2015 UNITED STATES ROTAX MAX CHALLENGE

BULLETIN 2015-8

Modified regulations: - **2015 UNITED STATES ROTAX MAX TECHNICAL REGULATIONS**

1. Coil pick-up

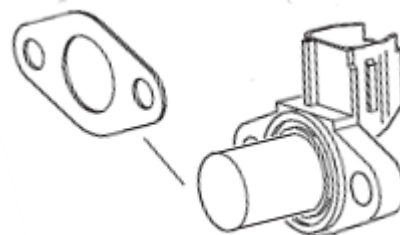
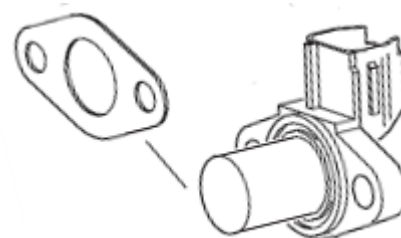
To fit the gasket (Rotax 431 500, thickness 0.8 mm) between the pick-up and the crankcase is an allowed option.

This section has been modified by the addition of:

To fit the gasket (Rotax 431 500, thickness 0.8 mm) between the pick-up and the crankcase is an allowed option.

A maximum of two gaskets are allowed to be fitted.

The fitting position of the additional gasket(s) (sequence of installation) is:

- a) *Crankcase → rubber sealing ring → additional gasket(s) → pick-up (recommended version); or*
- b) *Crankcase → additional gasket(s) → rubber sealing ring → pick-up.*
